Application reference number	2025/0930
-------------------------------------	-----------

Application Type	Variation of Condition
-------------------------	------------------------

Proposal Description:	Variation of condition 2, in relation to application 2020/1387 "Residential development of 7no. dwellings and associated works" to allow for amendments to house type D.
Location:	14 Roughbircworth Lane, Oxspring, Sheffield

Rear Elevation - Existing Approval Overlays

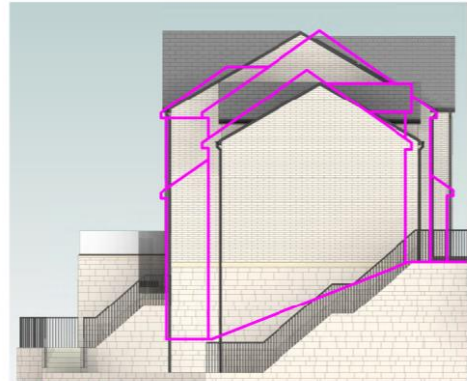
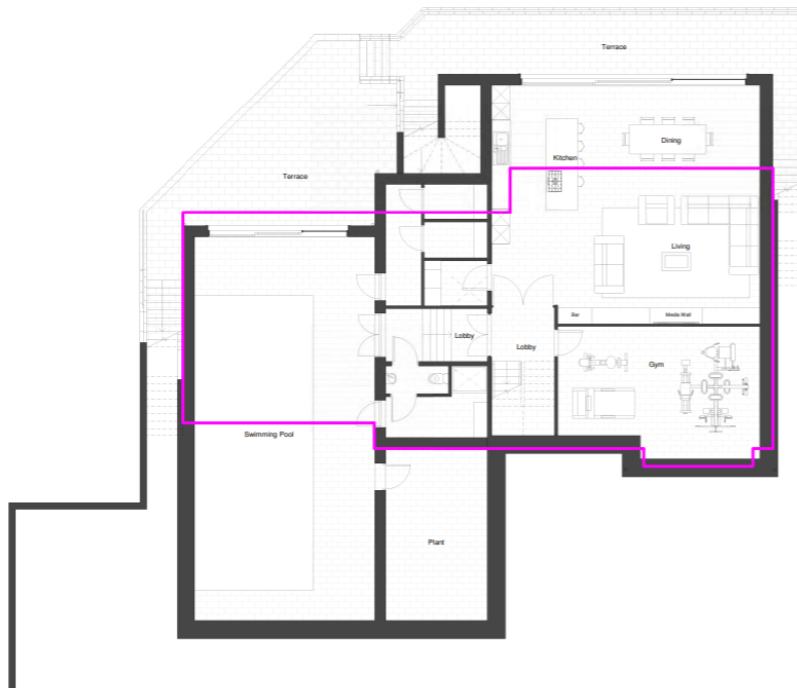
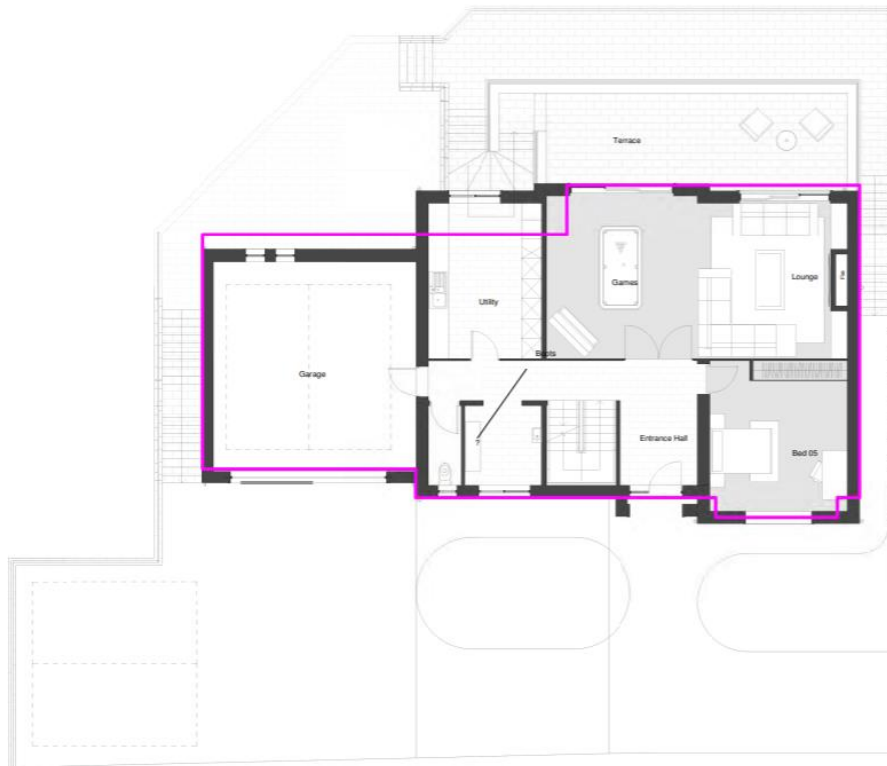
The first scheme submitted within the application was considered to be unacceptable as it heavily featured a vertical emphasis to the frontage and windows, which was not in keeping

with the original design and the design of the adjacent dwellings. With these individual elements emphasizing the height of the building and thereby not reducing its massing and scale, therefore amendments were requested. The applicant has now amended the scheme and has provided the following visuals in support of the revised scheme application.

The following justification has been provided: - 'The most notable change is the reduction in vertical emphasis across the elevations. The composition has been rebalanced to read more horizontally, with a clearer hierarchy of elements and a more traditional arrangement of built form. At the rear, we have also introduced a change in stone between the lower ground floor and the upper levels, which helps to visually break down the mass, reduce perceived height, and better anchor the building into the site.

We have also simplified the overall form by removing the larger flat roofed elements from both the front and rear elevations. This has allowed the building to appear more clearly as a series of traditional pitched roof forms, including the rearrangement of the rear gable, which helps reinforce a consistent architectural language across all elevations.

Fenestration has been carefully considered. The overall amount of glazing has been reduced and rationalised, and the previous vertical emphasis has been softened. Where vertical elements remain, these have been refined to reflect more traditional proportions. For example, the stair glazing has been amended from a single larger opening to two slimmer vertical slots, which is more in keeping with typical over-stair arrangements seen within the local area.

At the rear, larger openings have also been reconsidered and now take the form of more traditional arrangements, with large openings broken down and expressed with Juliet-style detailing rather than as expansive areas of uninterrupted glazing. This helps to better align the rear elevation with the overall architectural language of the dwelling, whilst still responding to the outlook and relationship with the other dwellings on the site which make use of Juliet style glazing.

Rear Elevation

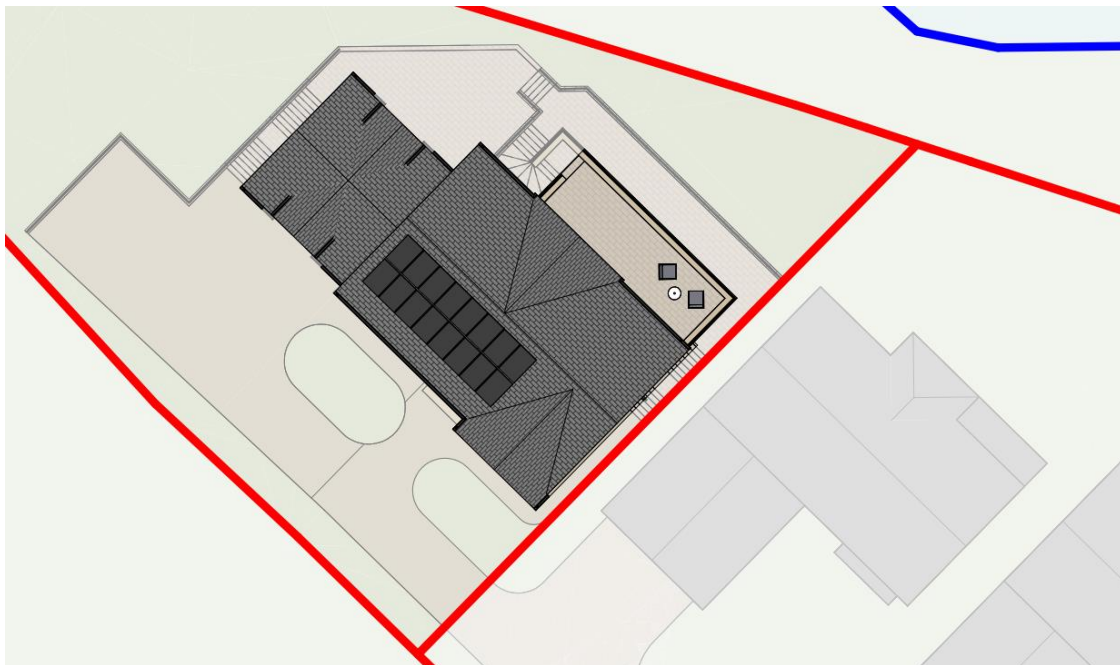
Concerns have been raised by neighbouring residents with regard to overlooking impact from additional windows and the proposed raised terrace area. A comparison of the house types is shown below. Whilst there are additional windows, the majority of the changes are set at lower ground floor level.

Turning to the rear terrace, this would not overlook the dwellings on Millstones significantly more than the existing windows or garden area at the plot. In terms of overlooking of the adjacent dwelling, the applicant's proposed dwelling and terraces are set back as can be seen on the proposed site plan below, and there are no habitable room windows impacted by the terrace in terms of overlooking or overbearing.

The dwelling backs onto the River Don and although it would be set at a higher level there is more than 21m back to back with dwellings on the other side of the river, in addition, as with the original application, the existing trees will be retained and new ones planted which will provide additional screening. On this basis overlooking to the rear is at acceptable levels. Where properties face existing houses on Roughbitchworth Lane, there is over 21m and privacy distances can be reduced when measuring front to front.
